Response to Request for Further Information
LRD Application DLRCC Reg. Ref. LRD22A/0930
Proposed residential development at Dalguise House,
Monkstown Road, County Dublin

Response to Request for Further Information

Figure 2.2: Locations of live BTR applications within a 1km search radius from the subject site, with approximate boundary of subject site highlighted in red. (Source: ESRI Basemaps, NPAD, cropped and annotated by TPA, 2023.)

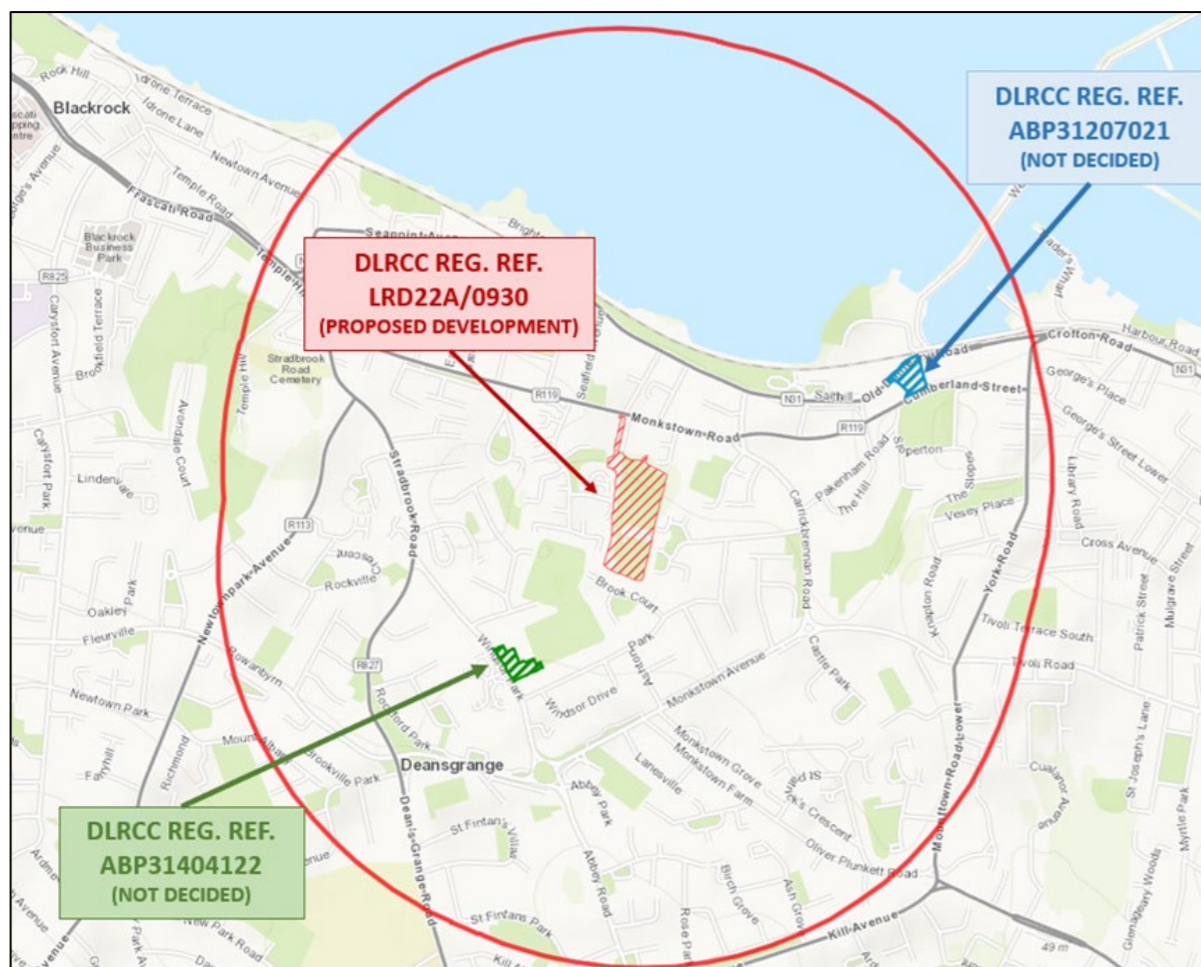
“The applicant has not adequately demonstrated that the proposal does not result in a proliferation of BTR accommodation with an appropriate mix within the wider area and within the site, in accordance with Policy PHP28 of the current County Development Plan. In this regard the applicant is requested to provide details of all existing and permitted BTR apartments within 1km catchment of the site. The details provided should include the location, the number of apartments and unit mix.”

The proposed BTR developments, if all were permitted and developed, which is not certain to occur, would increase the number of units in the area by an additional 11.7% (this figure excludes any ‘conventional’ residential schemes that may be permitted in the same period). The BTR units would amount to 10% of the new total of 7,089 no. units in the 1km study area. (Albeit this figure excludes ‘conventional’ residential units under construction without Eircodes, or permitted and developed in the same period, and the actual percentage may be lower).

Figure 15.1: Block J access at Planning Application Stage vs Further Information Stage. (Source: Cameo RFI Response Report.)

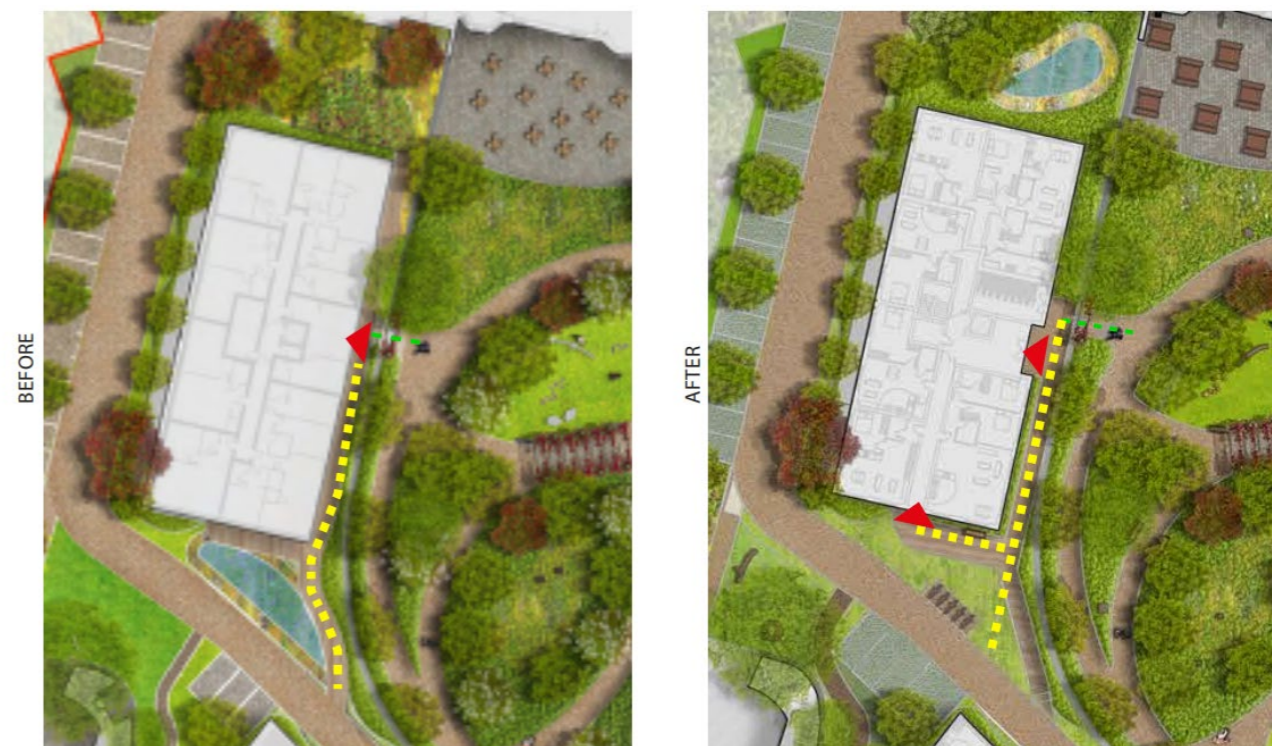
“Pedestrian access to Block J includes stepped access. The alternative inclined boardwalk access from the rear of the site is noted, however, an alternative access adjacent to the main entrance should be provided.”

An additional ground floor building entrance has been provided for Block J at the southern end of the Block. This access, via the boardwalk is the primary entrance, as it is approached at a gentle slope. The unit mix in Block J has altered with a 3-bed unit replaced by a 2-bed unit in order to accommodate the new entrance.

Figure 29.1: Test trenches (identified in blue) were dug throughout the site (identified by the redline). (Source: Figure 3, IACL Archaeological Assessment, 2023.)

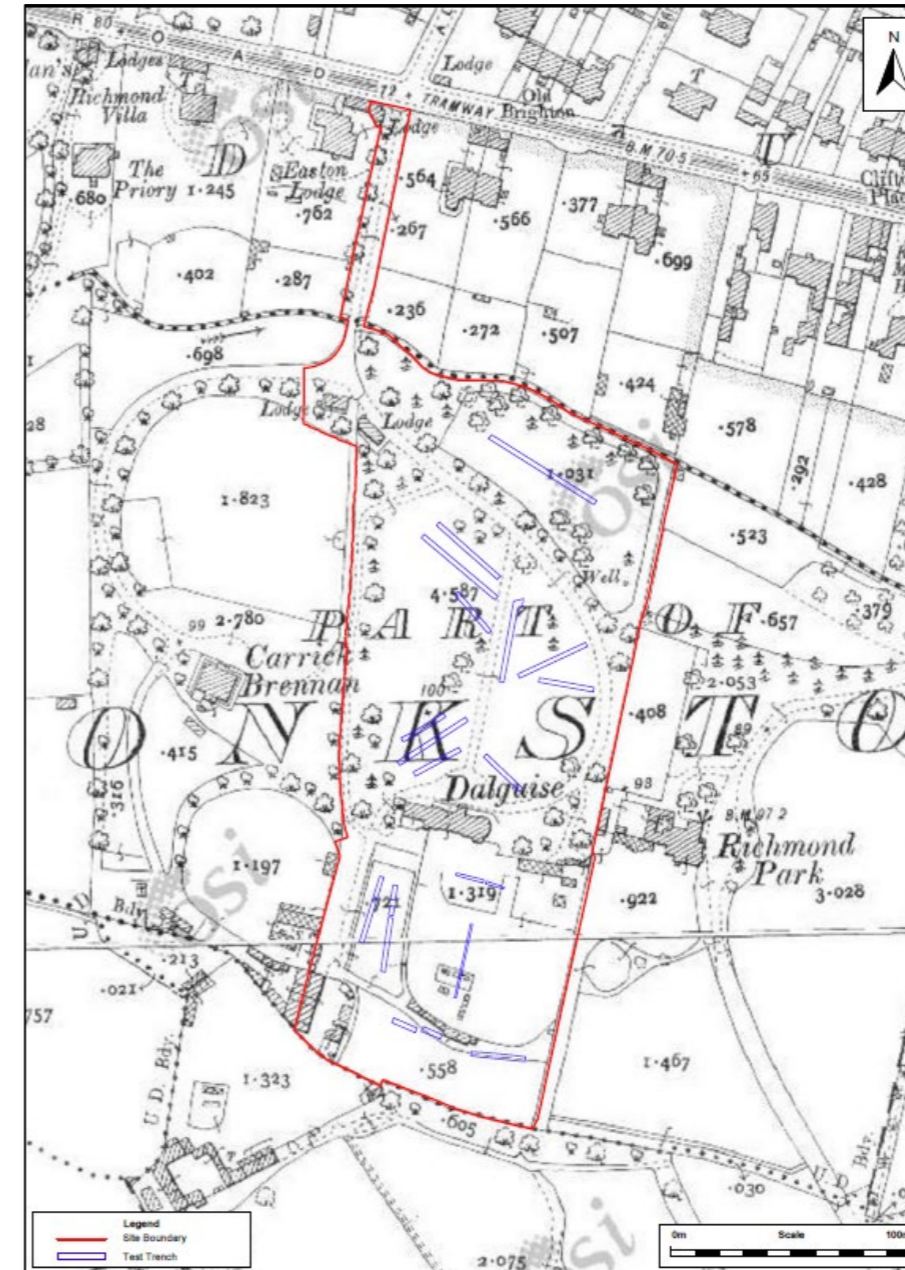
It is recommended that all topsoil stripping associated with the proposed development be monitored by a suitably qualified archaeologist. *If any features of archaeological potential are discovered during the course of the works further archaeological mitigation may be required, such as preservation in-situ or by record. Any further mitigation will require approval from the National Monuments Service of the Department of Housing, Local Government and Heritage.”*

The Applicant is willing to accept a Condition which requires that all topsoil stripping associated with the proposed development be monitored by a suitably qualified archaeologist as per the recommendation of the Archaeologist.
